Theatre Salina Expansion – Proj #22-3239

ADDENDUM NO. 4

THEATRE SALINA
DANCE STUDIOS & SCENE SHOP EXPANSION
SALINA, KANSAS

A2.1

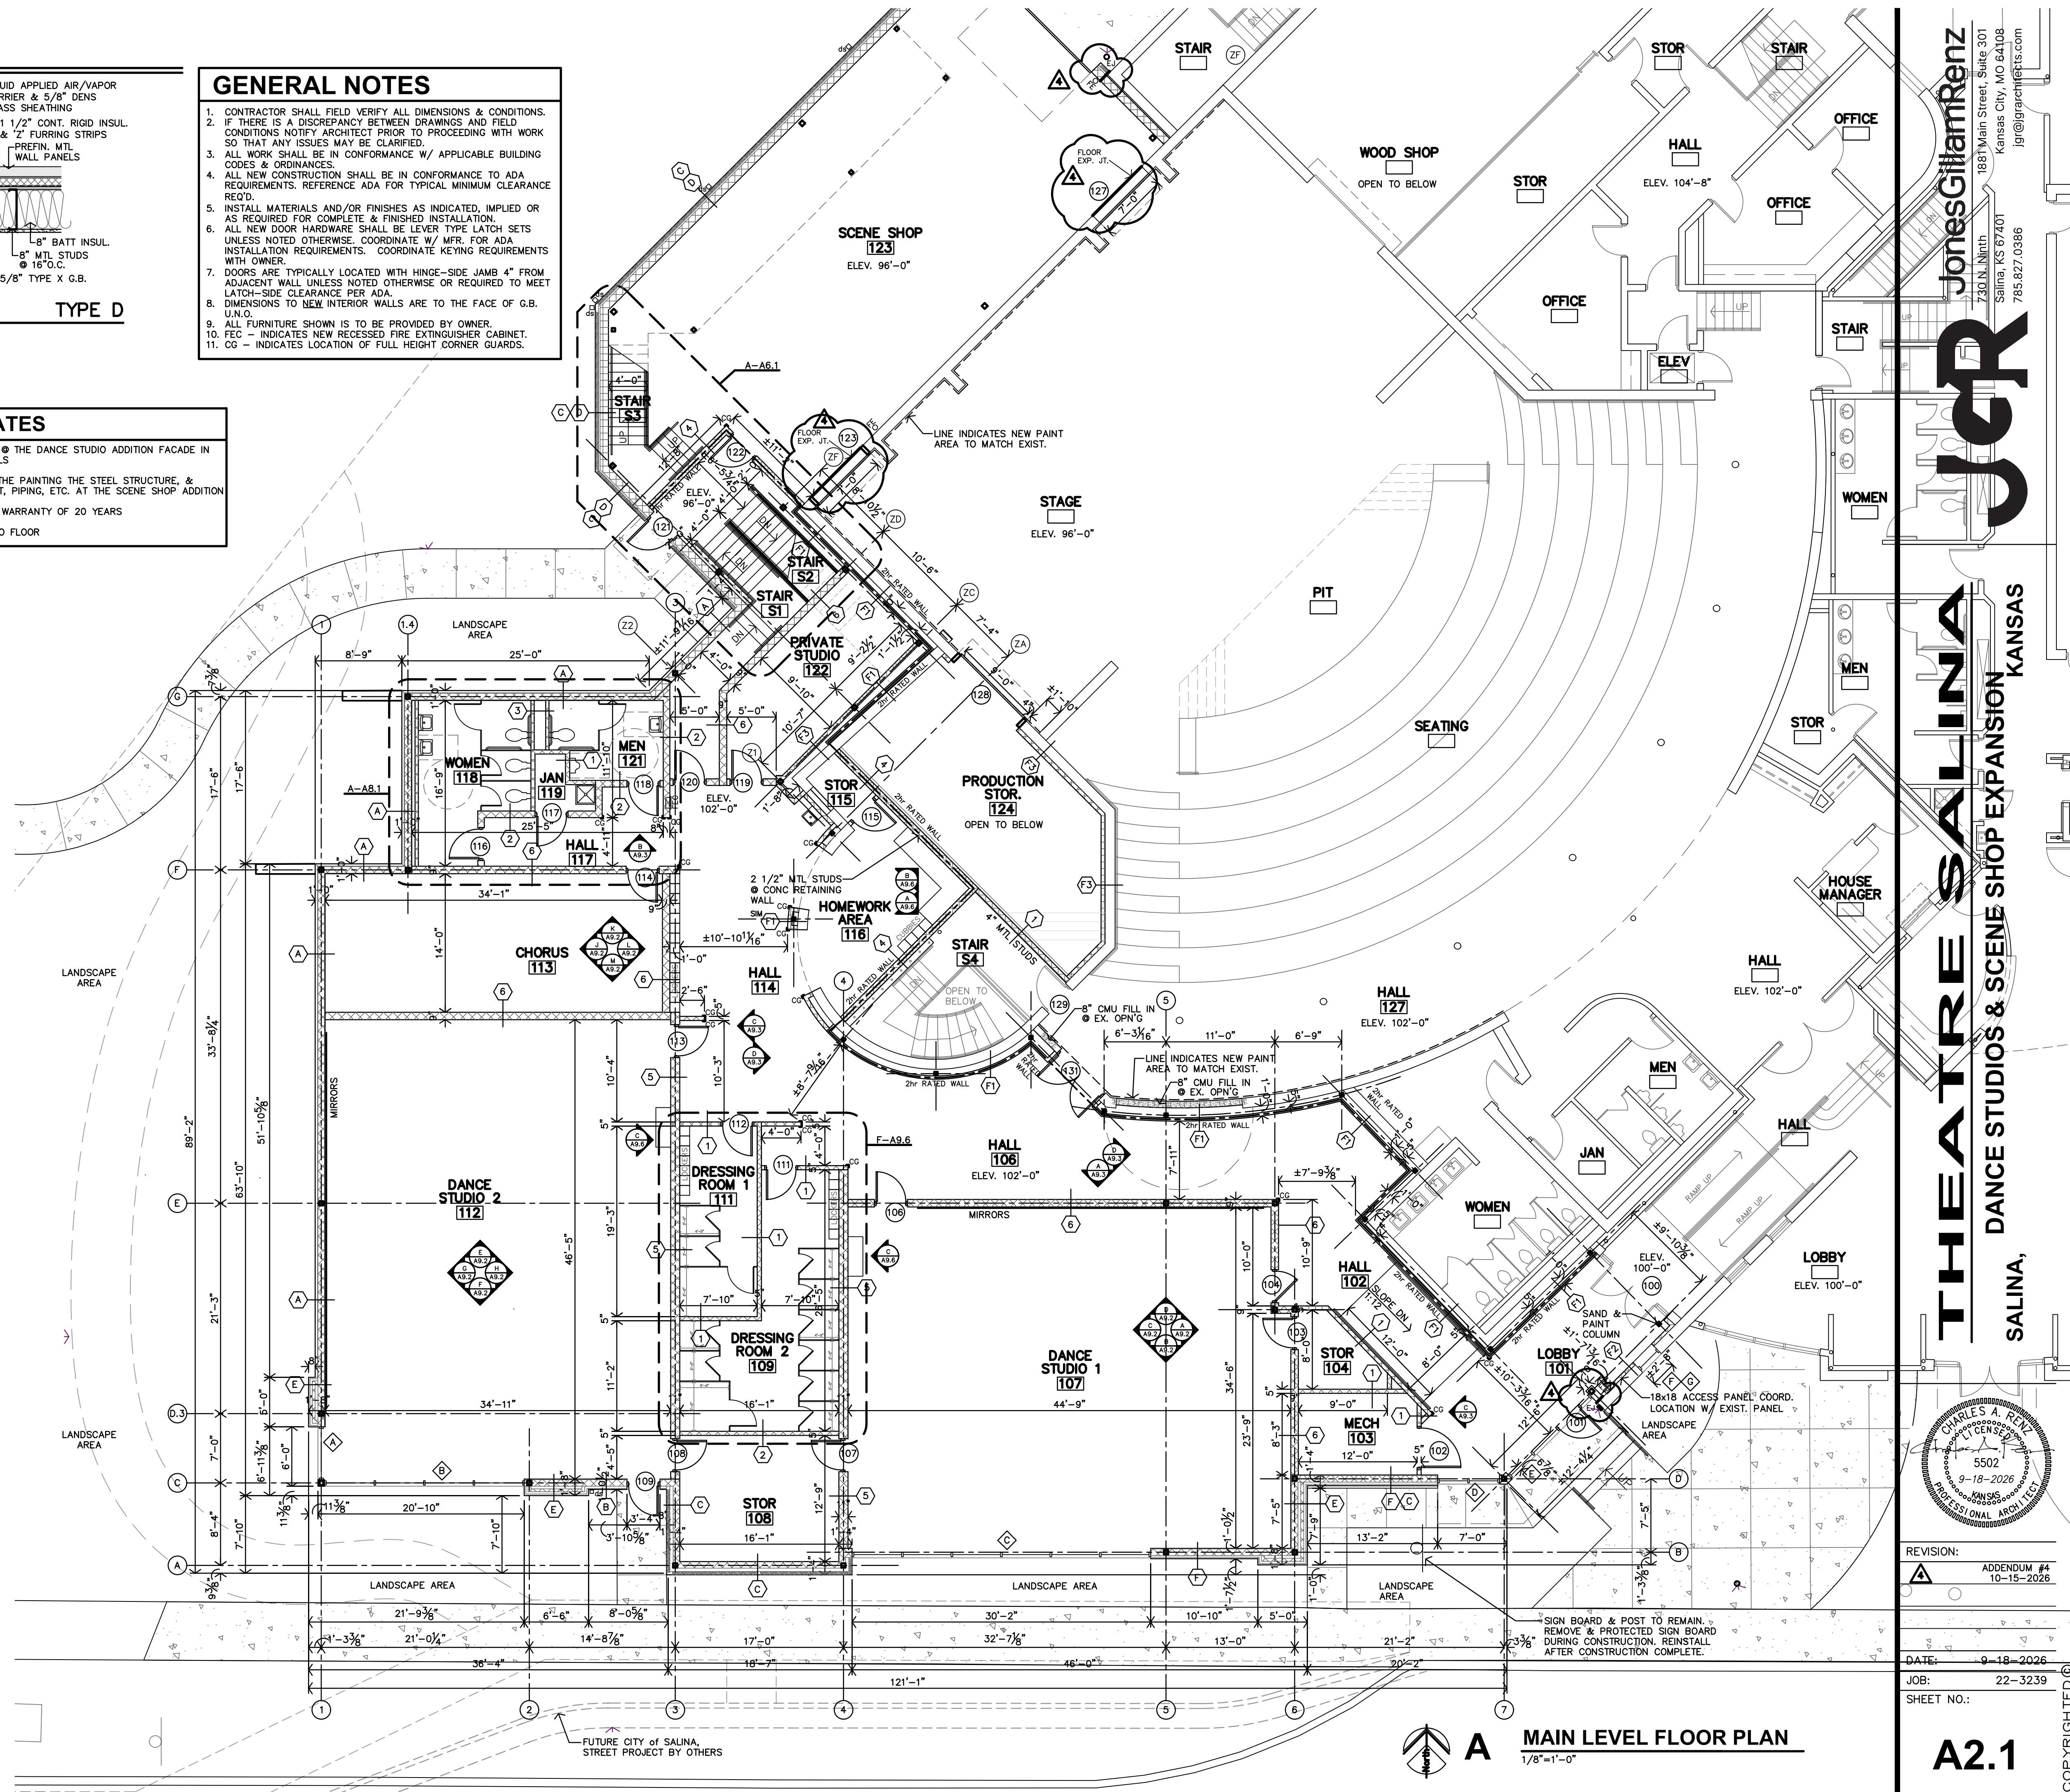
1. Section 10850 Building Specialties, Paragraph 1.05 Expansion Joint Covers, Paragraph A. Delete reference to Hall 006 and Hall 124. Reference the attached Revised Sheet A2.1 for expansion joint cover locations at walls.
2. Section 01019 Special Provisions – Paragraph 5.f.2 – Clarification, the signage allowance is to be used for building signage that is not currently identified on the drawings. This shall include restroom signage, wall mounted room signage, dedication signage, etc. The exterior metal "Inspire" sign and the (3) vinyl wall graphic "Studio" graphics are to be in the base bid.
3. Section 10850 Building Specialties, Paragraph 1.03 Cast Metal Letters, - Clarification, this cast metal lettering is to be backlit with LED lighting.

A4.6

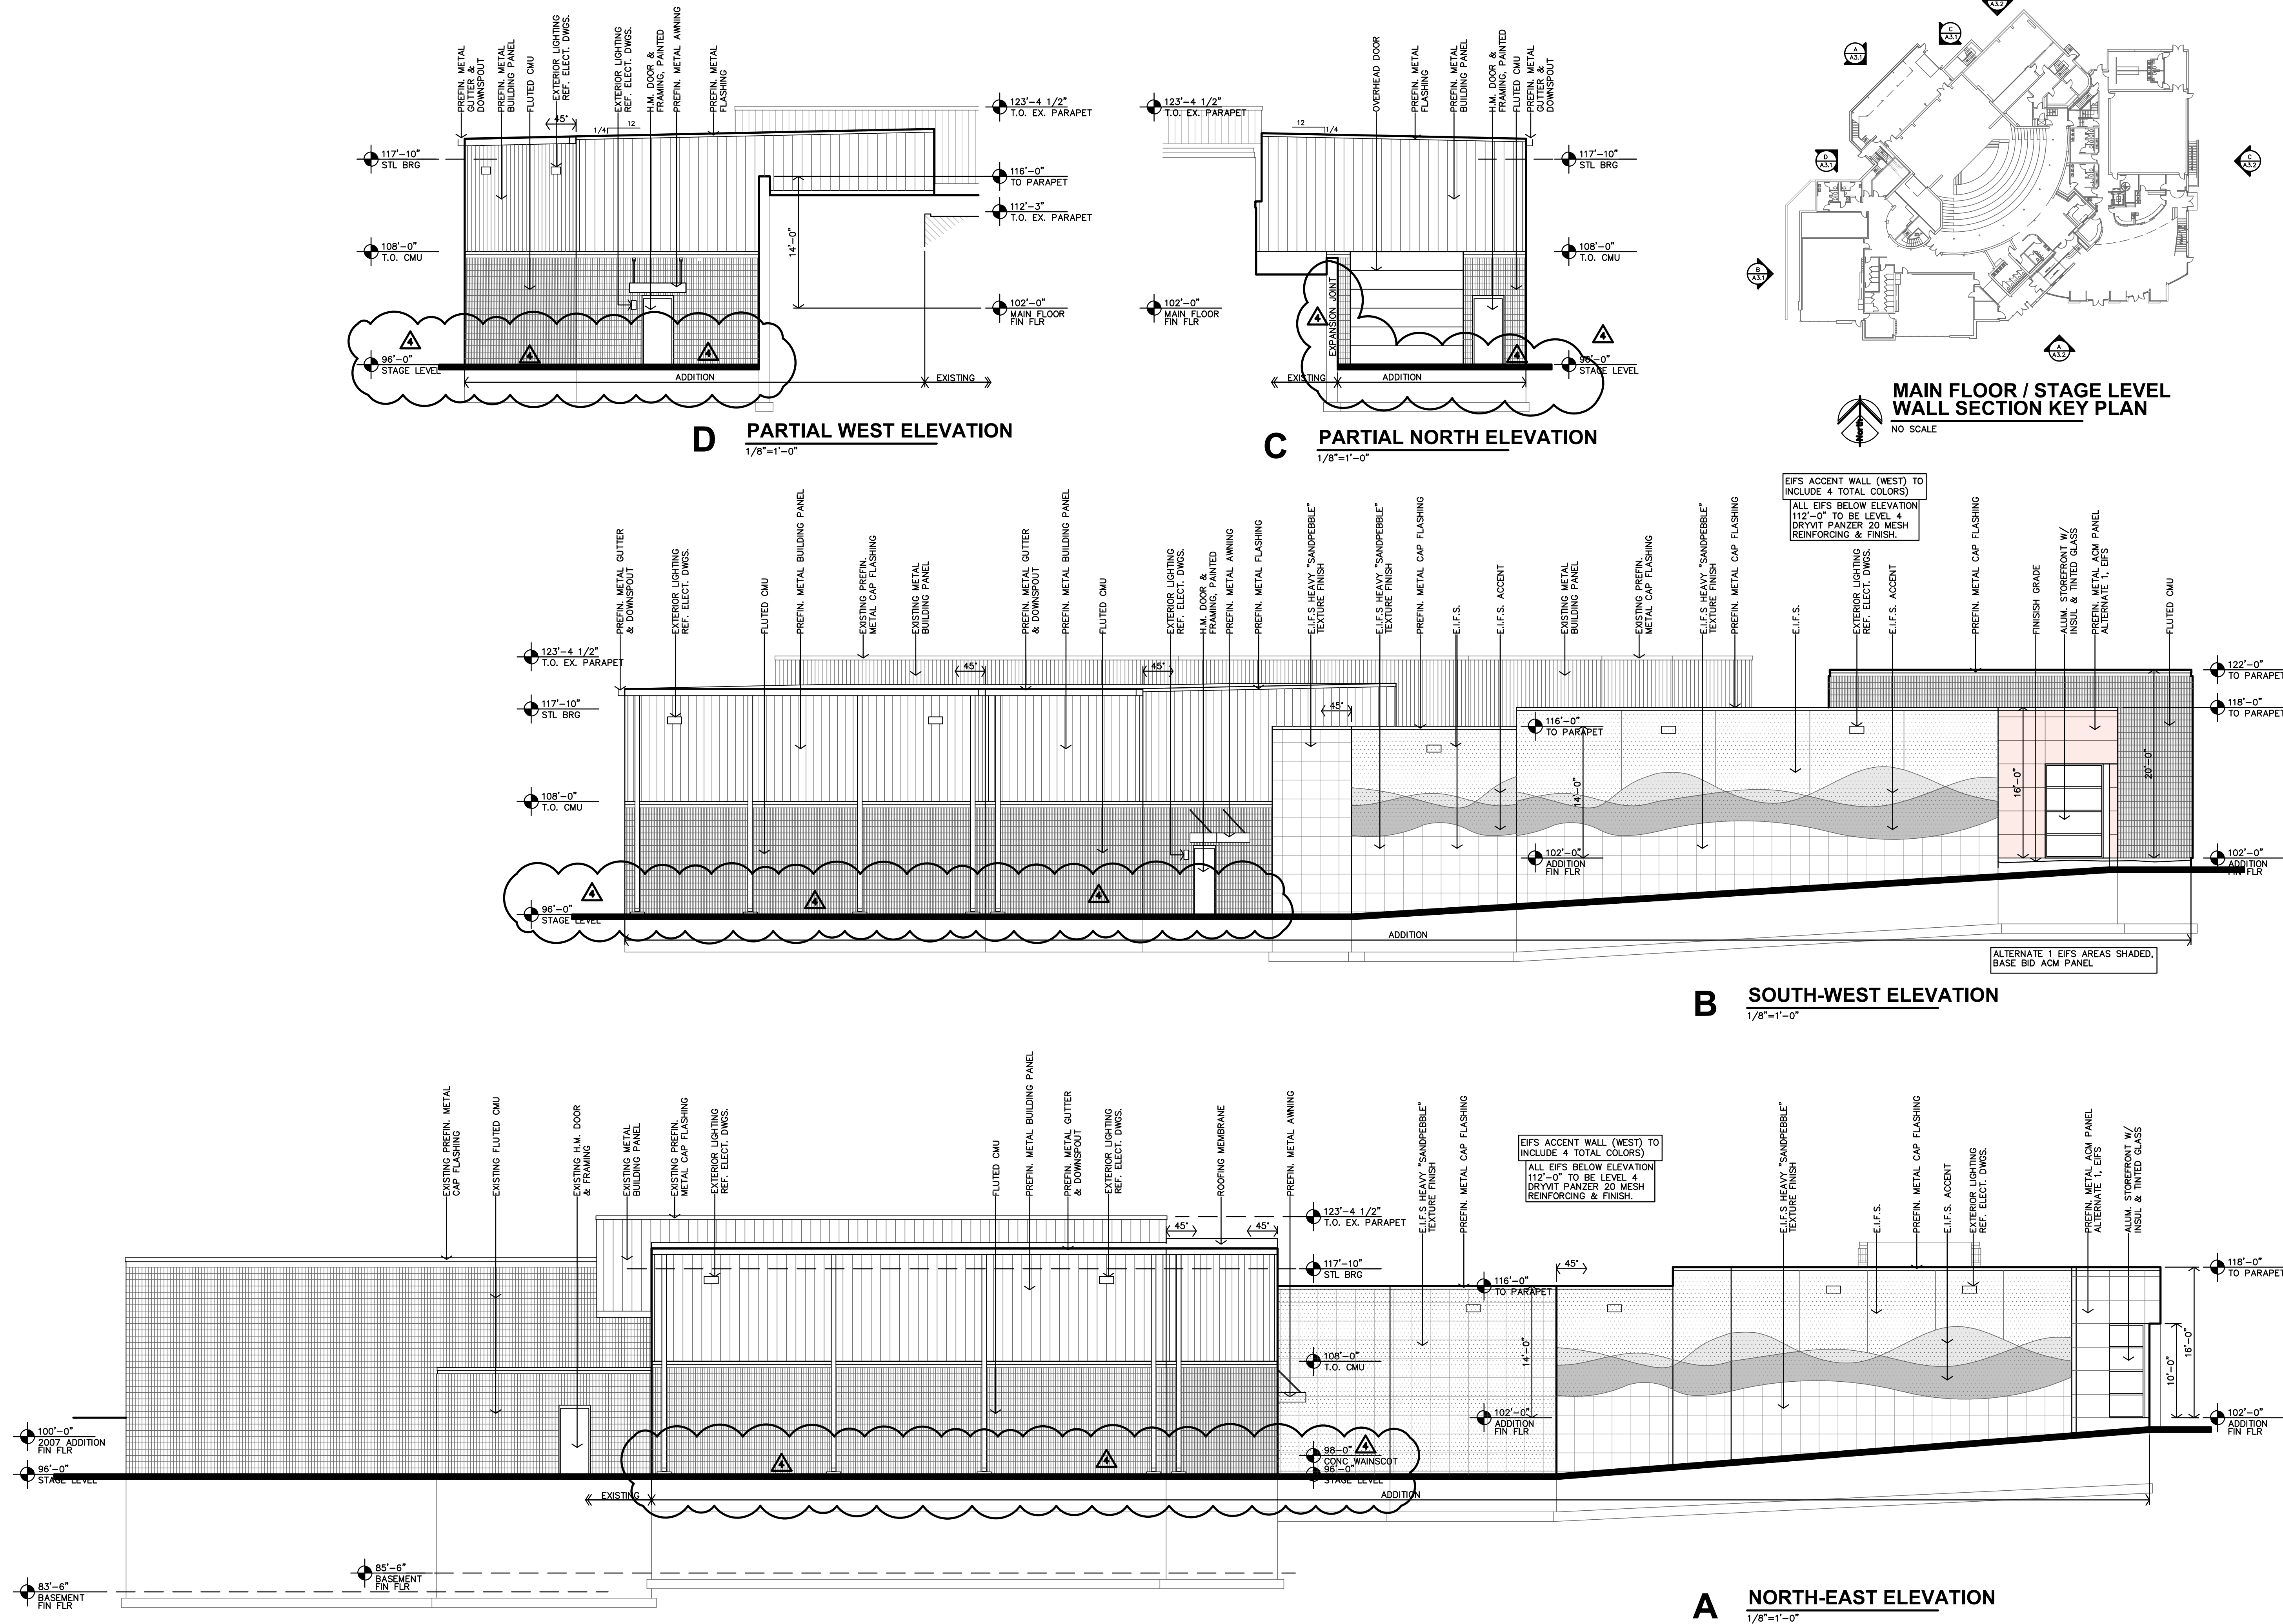
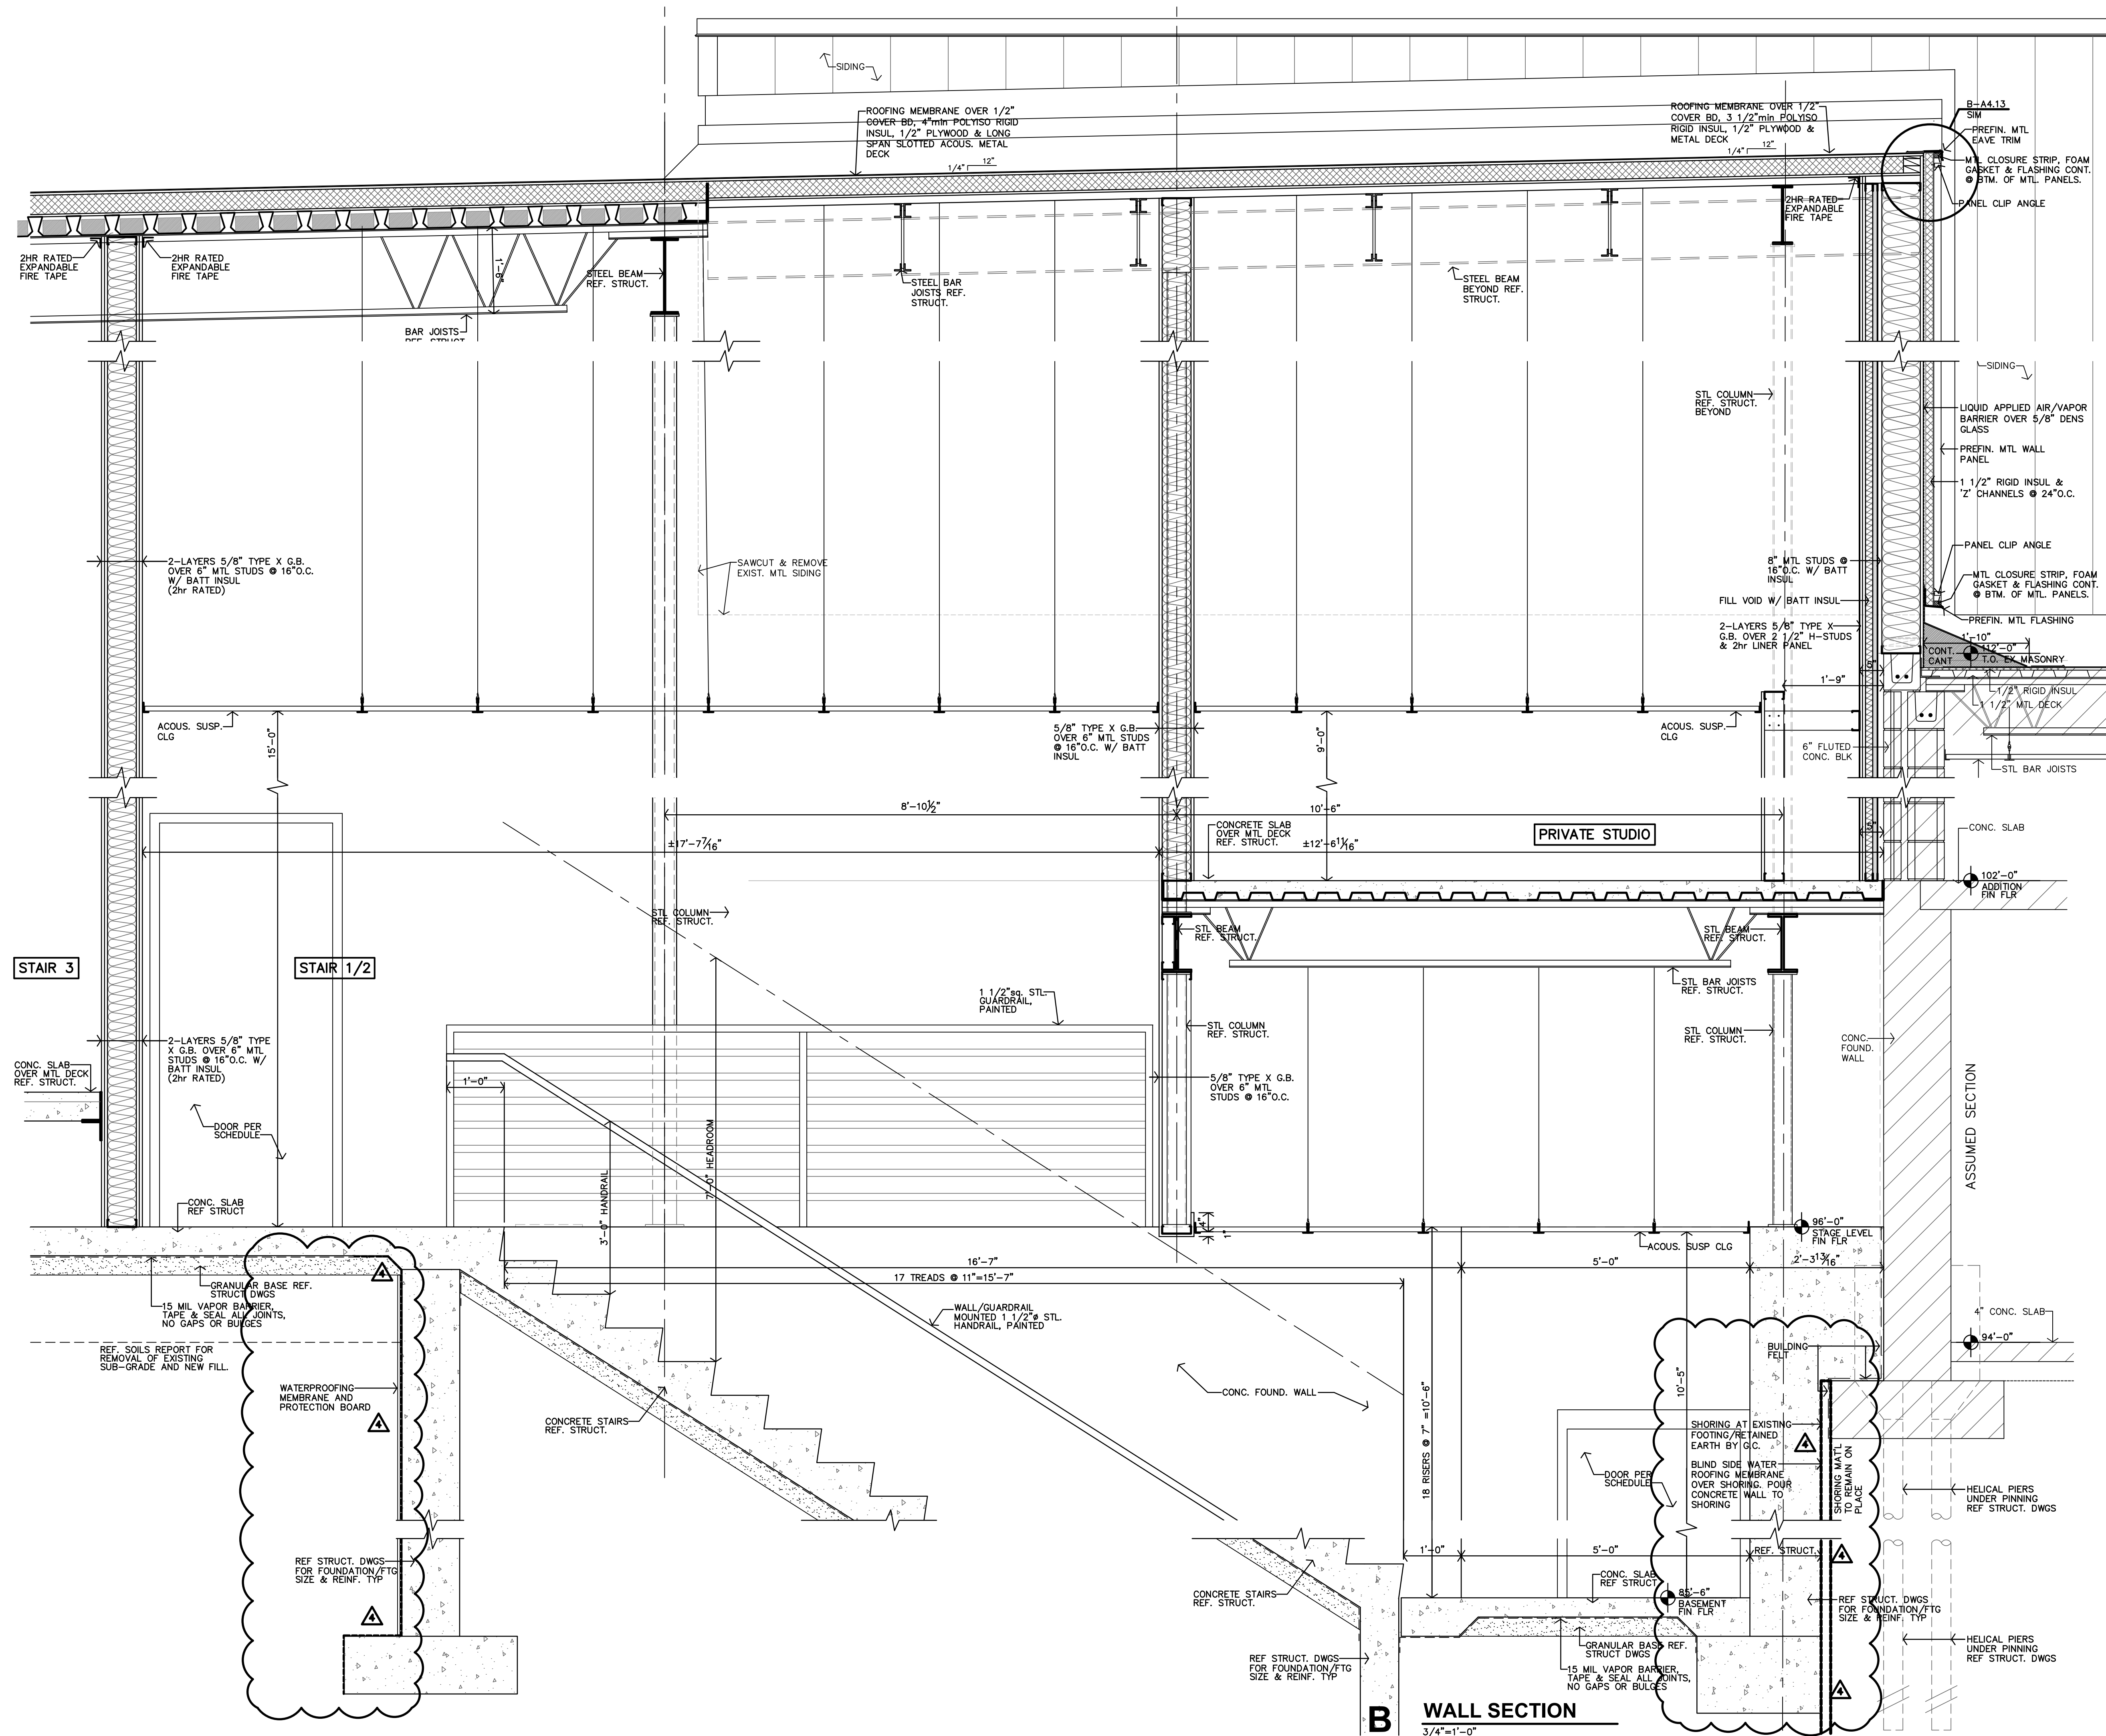
3. Sheet A4.5 and A4.6 Wall sections - Clarification, all new walls exposed to basement areas, including Stairs S1/S2 shall be waterproofed with membrane waterproofing and protection board per specifications. Reference the attached revised sheet A4.5 and A4.6.
